A66 Northern Trans-Pennine Project

7.24 Applicant's Responses to the Examining Authority's Written Questions

**7.24 APPLICANT'S RESPONSES TO THE EXAMINING AUTHORITY'S
WRITTEN QUESTIONS**

Deadline:	Deadline 4
Planning Inspectorate Scheme Reference	TR010062
Application Document Reference	NH/EX/7.24
Author:	A66 Northern Trans-Pennine Project, Project Team, National Highways

Case IH CVX 160 Tractor & 8m Drawbar Trailer
Drive out of location

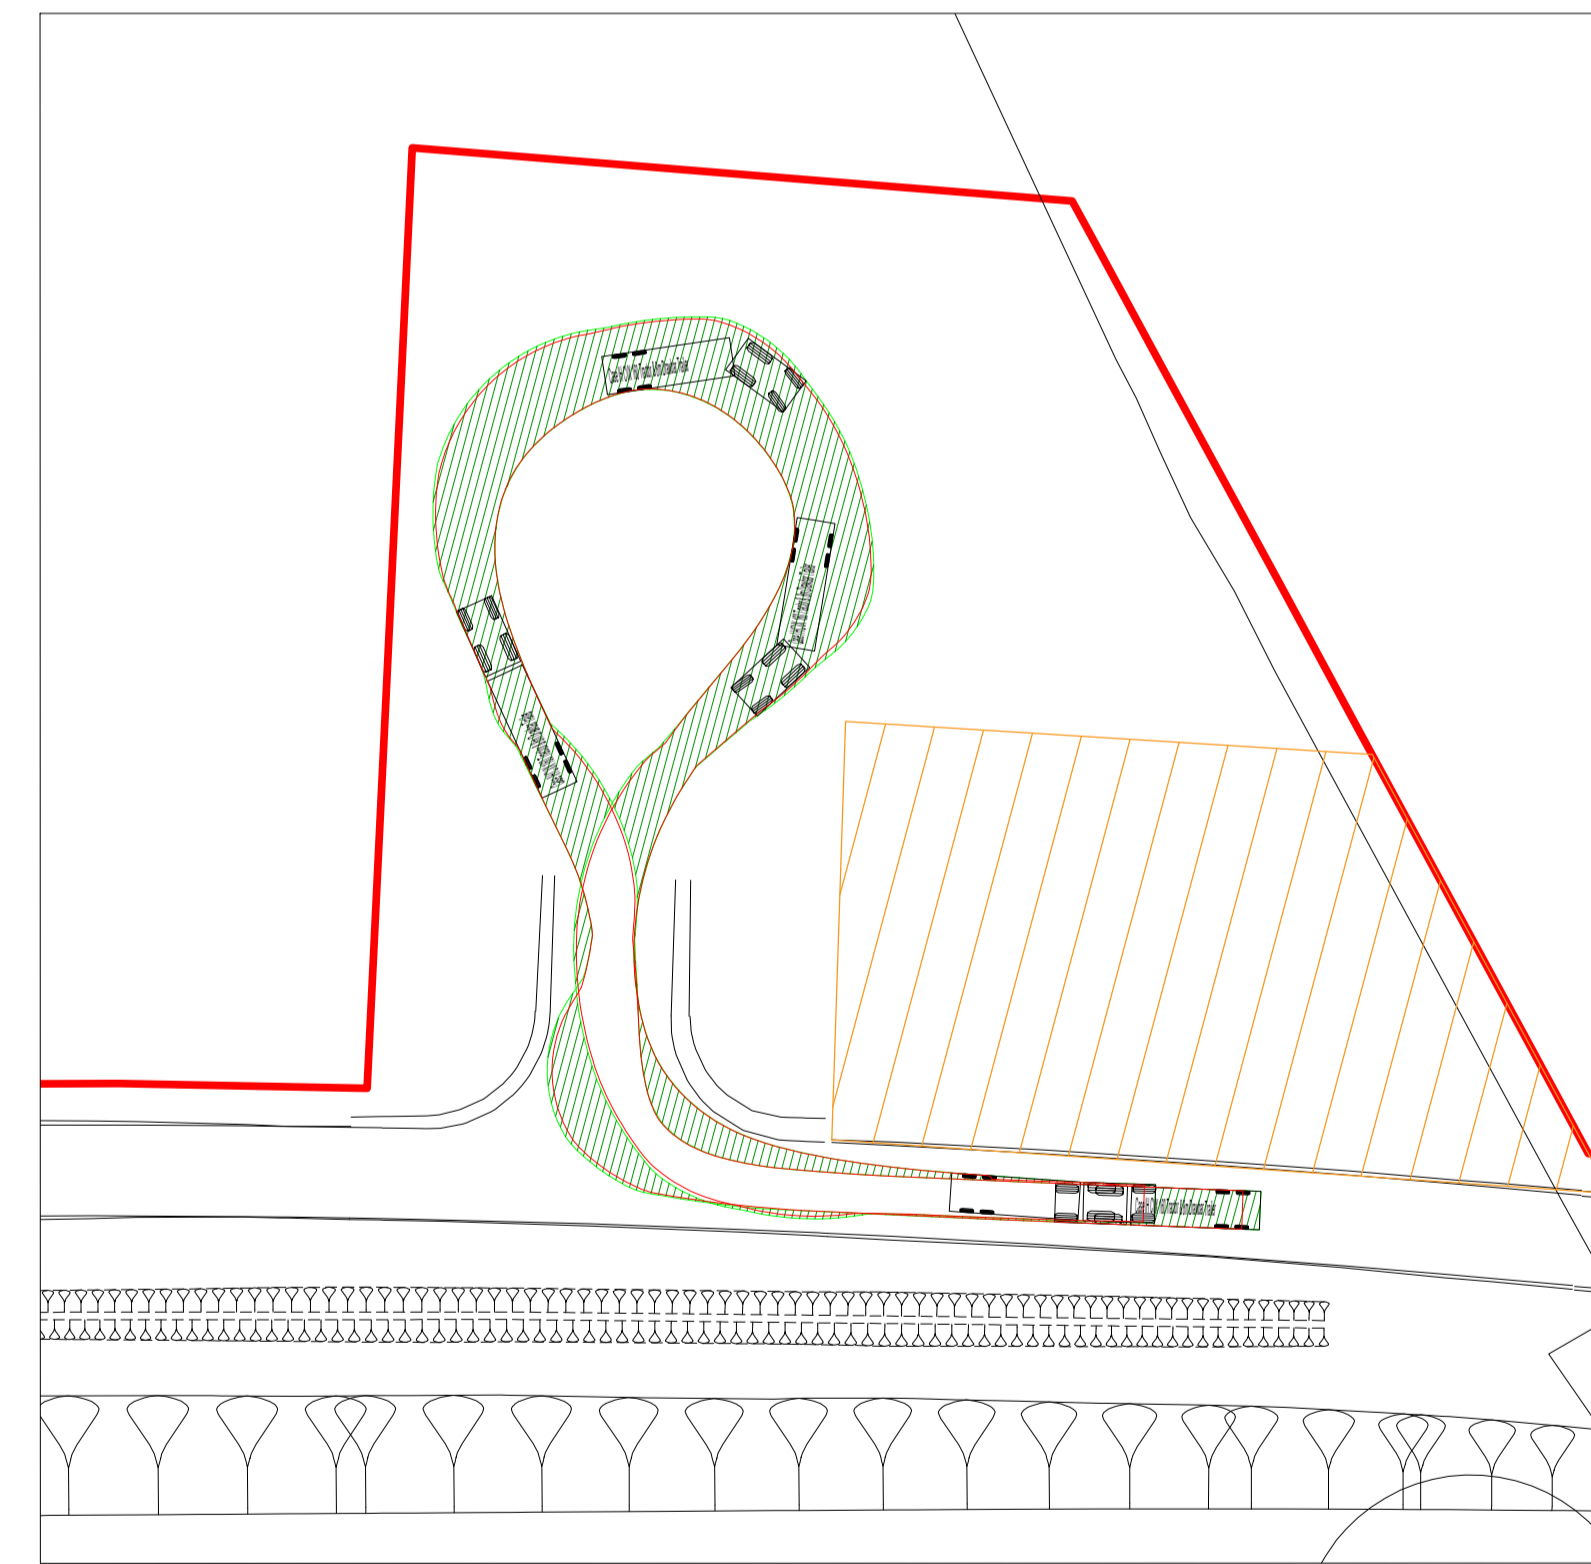
CA 1.9	Impact from CA	The Applicant	Explain how has the "additional space for vehicle turning" for W Austen Richardson Ltd been 'sized' in the context of vehicle dimensions and turning circles [REP1-136, para 2.6.1 and REP2-015, page 64]. Any response could be in a plan form.	Please see the plan within Appendix A to this document which shows an area for a replacement slurry tank and associated indicative swept path arrangement for vehicles to access and manoeuvre within the adjacent space (sketch ref:HE565627-AMY-HAC-S09-SK-CH-701205.). This is located on plot 09-01-19 as shown on Sheets 1 and 2 of the Stephen Bank to Carkin Moor Land Plans (APP-310). The area for the replacement tank has been sized based on the existing tank. Additional space is included, to provide for flexibility in locating the tank. Vehicle swept paths are based on a 16.5m articulated lorry and for a tractor/ trailer combination. Options have been shown for the vehicles to drive in and turn around in one movement or to adopt a stop and reverse manoeuvre. Further discussions will be required with the landowner as to the preferred option and sizing of the tank and turning area to allow refinement where possible, but it is clear from the plan provided in Appendix A that there is sufficient space to accommodate the desired vehicle movements.

3.2. Appendix B: FDW 1.9 Flood Compensation Areas

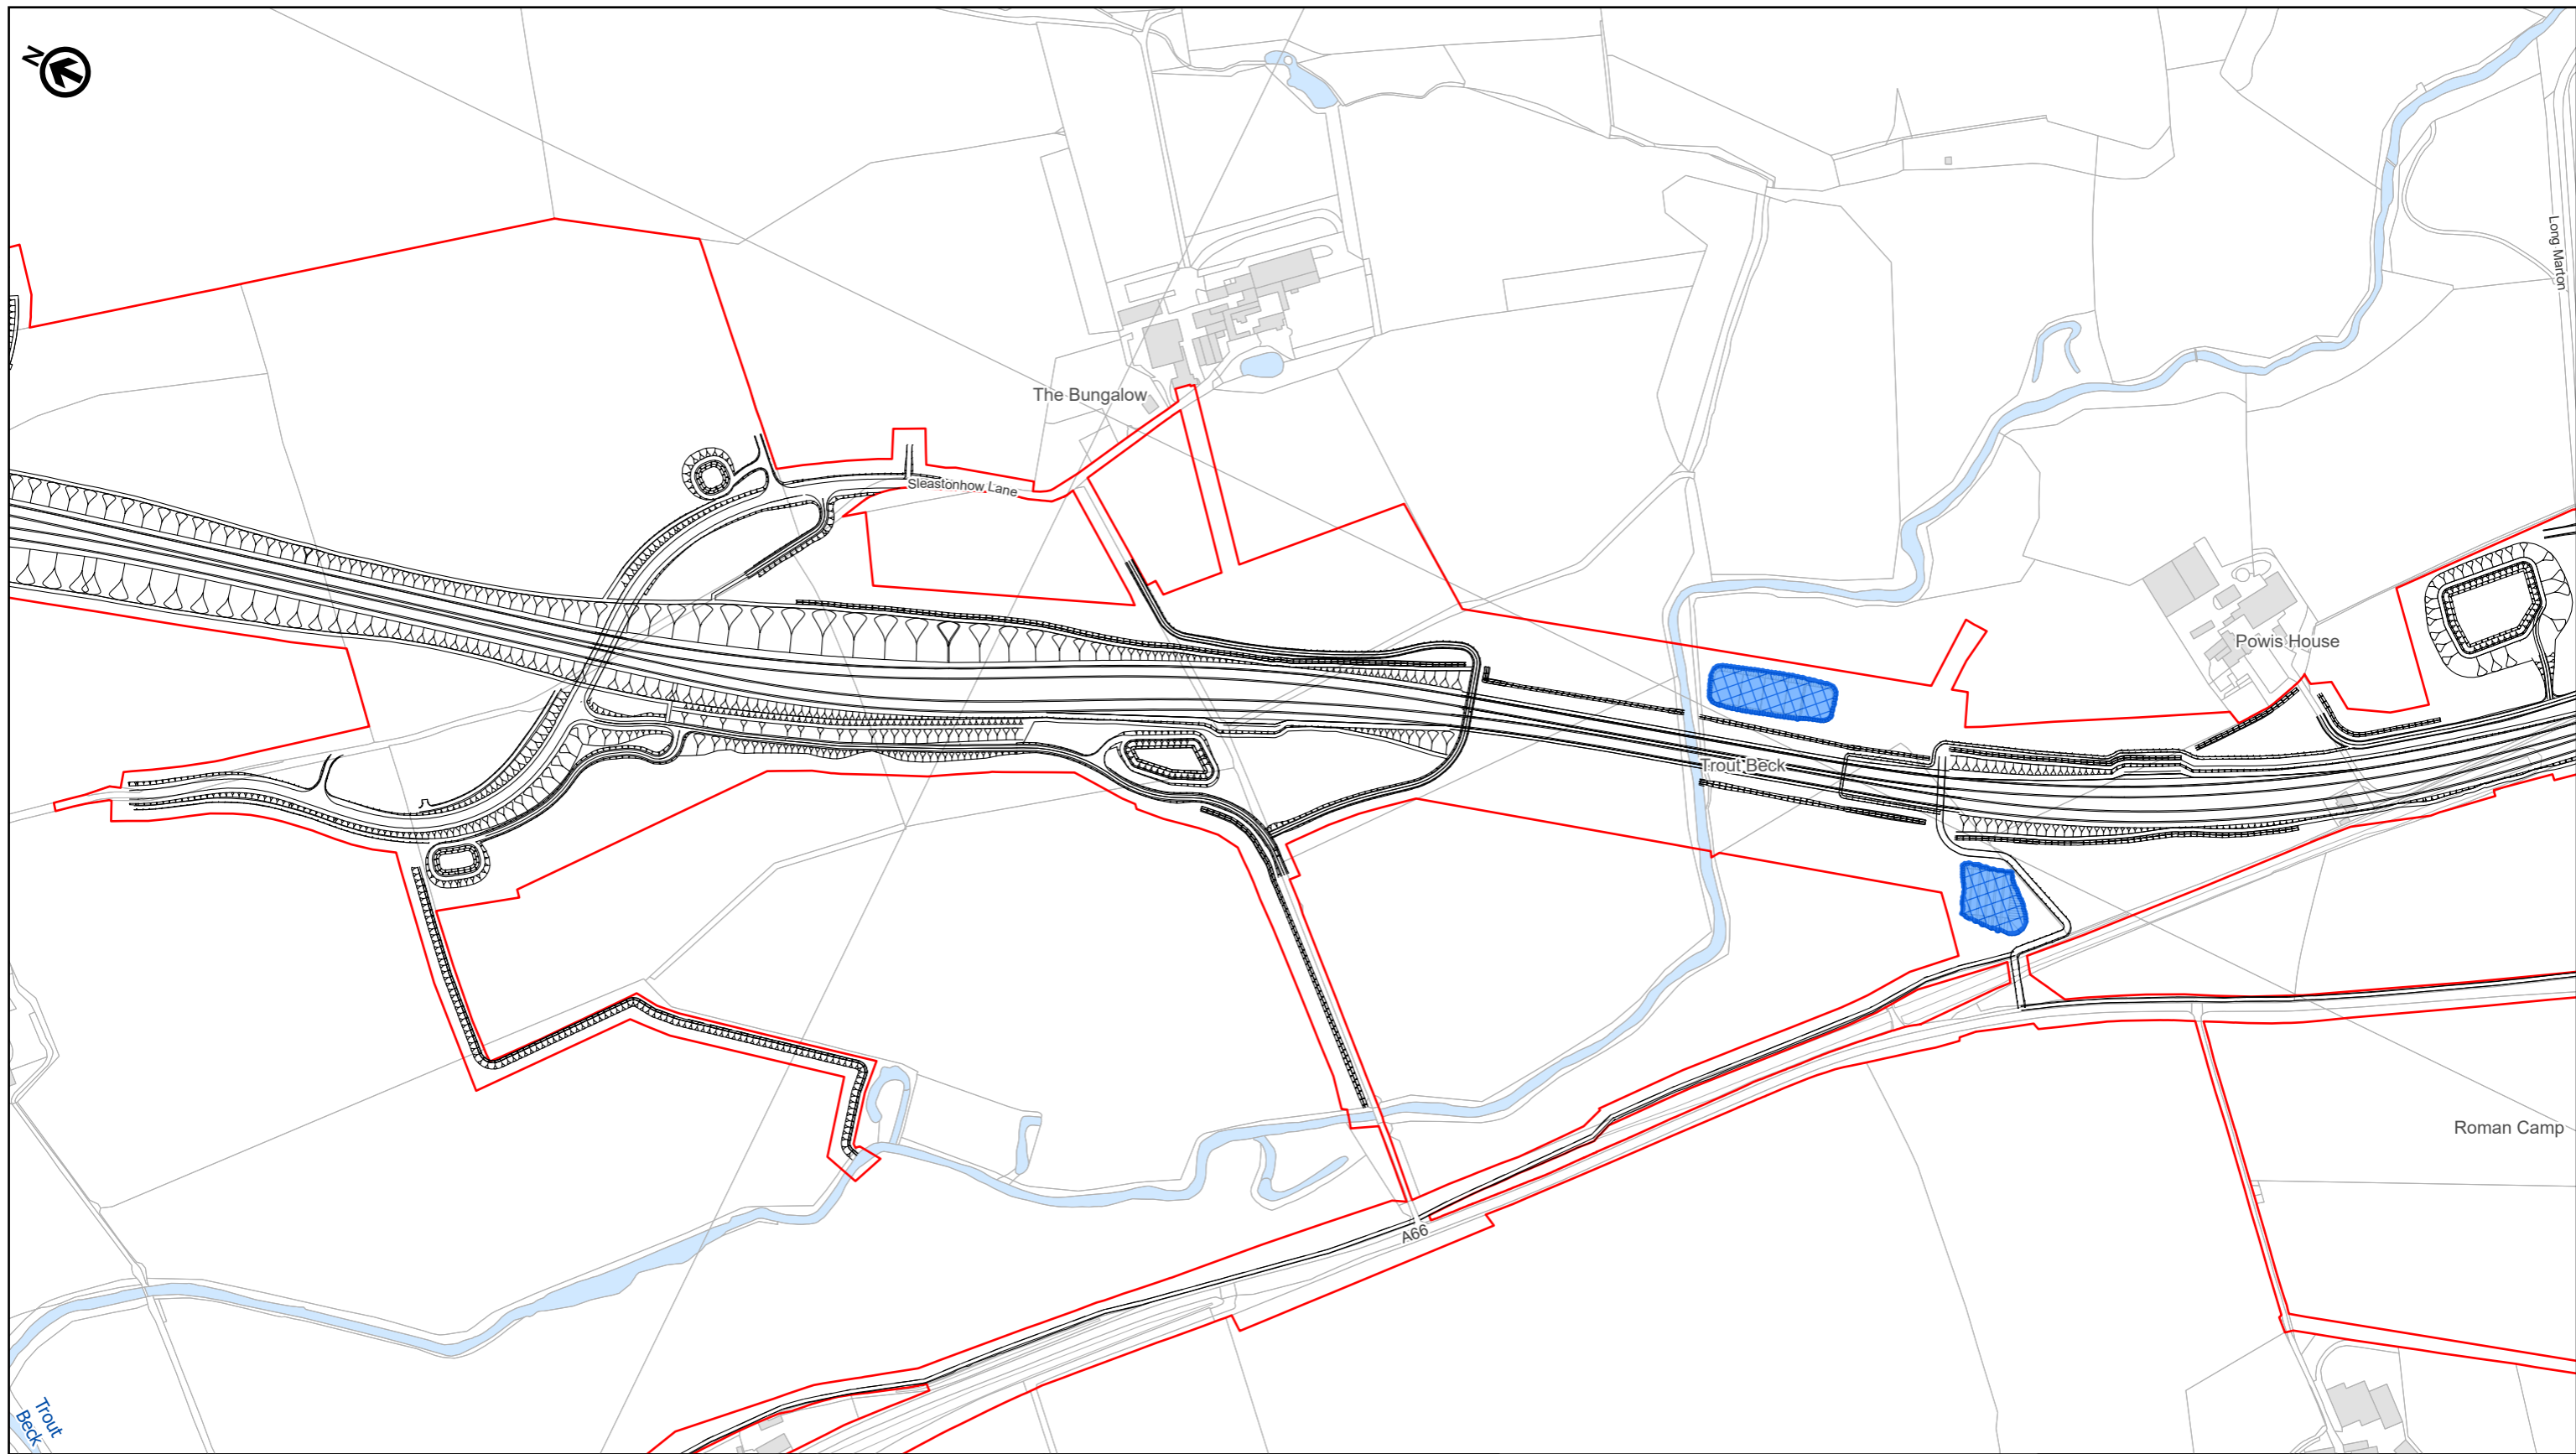
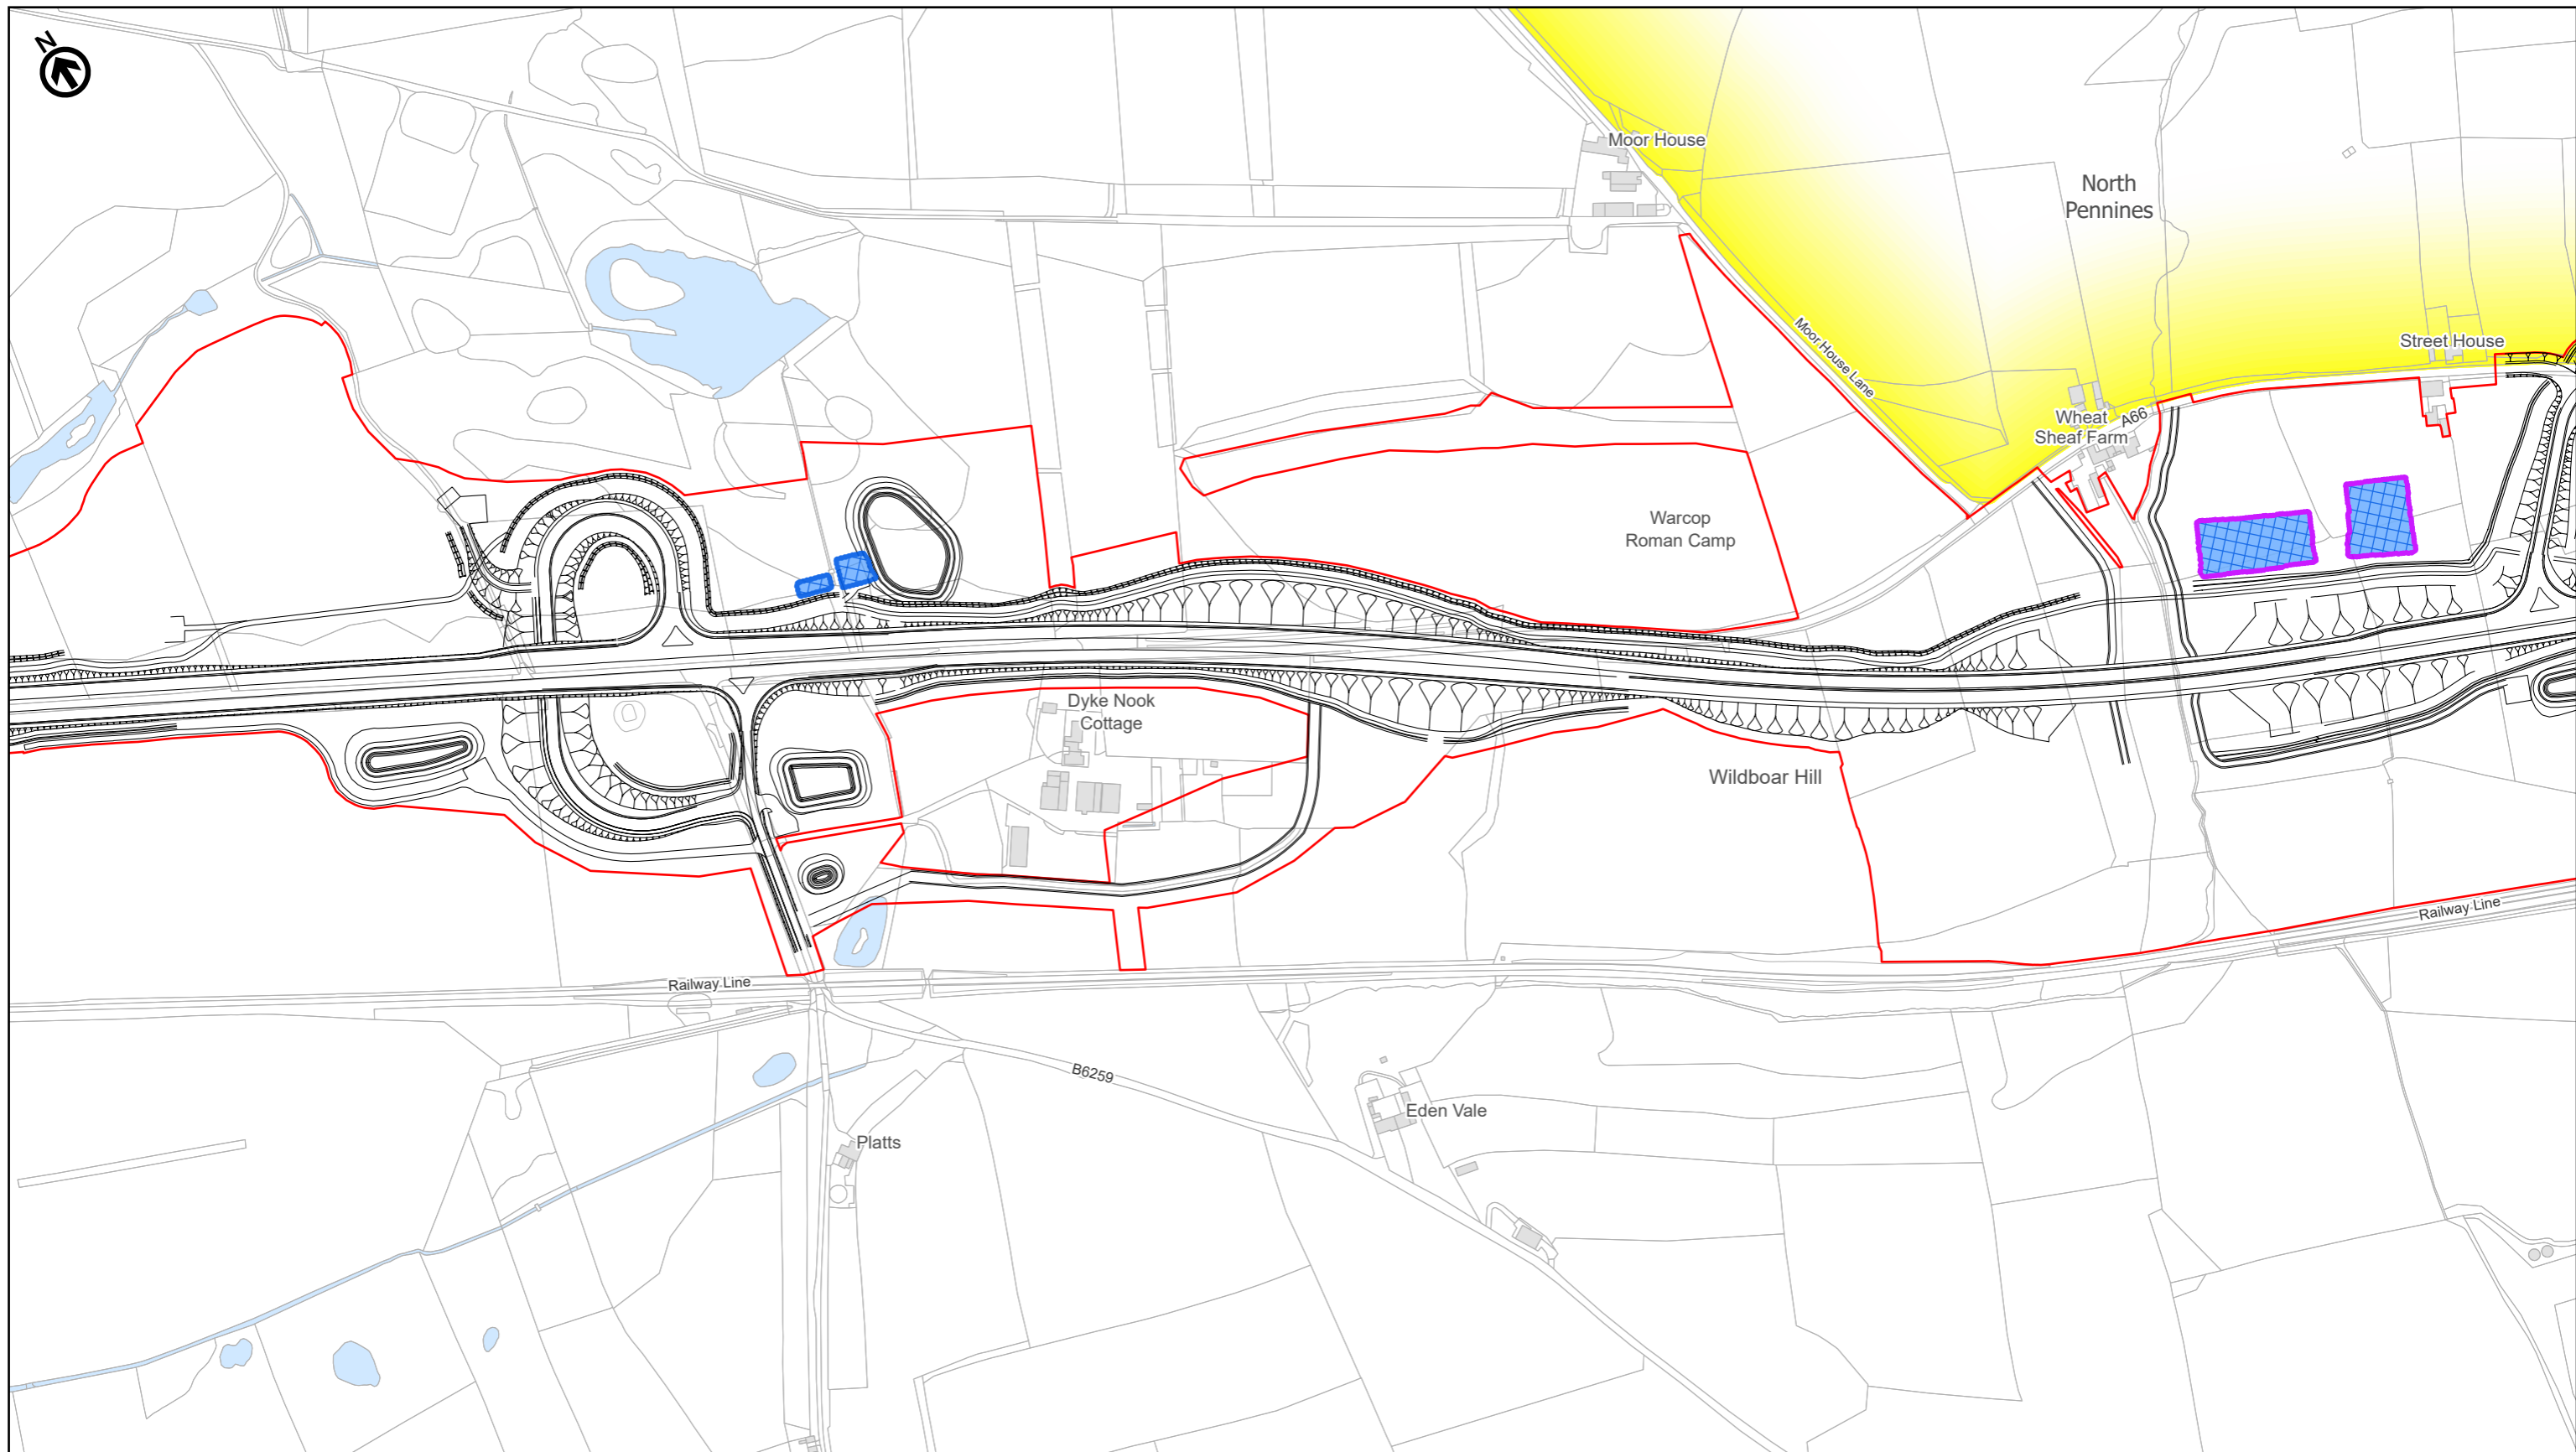
FDW 1.9	Preliminary Drainage Design	The Applicant	For each scheme, provide a set of plans to identify 'level for level' compensation and 'indirect storage (or volume for volume compensation)' areas [APP-221, para 14.2.5.132 and Plate 4]. This set of plans should be in a similar format to the environmental mitigation maps [APP-041] and could be added to the mitigation maps if the Applicant considers this to be a better way of comprehensively	<p>Flood compensation areas have been designed for the Main Rivers in Scheme 4,5 and 6. A separate set of plans has been prepared (see Appendix B of this document) to highlight the compensation areas proposed for these schemes. The plans are based on the Environmental Mitigation plan style and sheet numbering system. For clarity, only sheets that include flood compensation areas have been provided.</p> <p>The location and shape of the mitigation measures shown on the plans provided demonstrate how they can be incorporated into the detailed design of the Project, but are subject to re-location and/or further refinement at the detailed design stage, in accordance</p>

Ref Number	Subject	Response by	Question	Applicant's Response
			identifying the future purposes of land within the Order limits in terms of any Compulsory Acquisition of land and rights.	with the provisions of the Environmental Management Plan (Application Document 2.7, [APP-019] as updated) and the Project Design Principles (Application Document 5.11, [APP-302] as updated), see in particular measures D-RDWE-12 (which requires consultation with the statutory bodies that possess functions relevant to the control of flood risk) and D-RDWE-13 (which requires further hydro morphology and geomorphology assessments to determine flood compensation storage requirements) and D-RDWE-14 (which makes provision for further flow modelling in relation to the works associated with Warcop Junction). Subject to detailed design carried out in accordance with the Environmental Management Plan and Project Design Principles, other flood compensation areas may be required in other areas of those Schemes or in respect of other Schemes and so, in relation to land requirements the plans contained in Appendix B are not definitive..
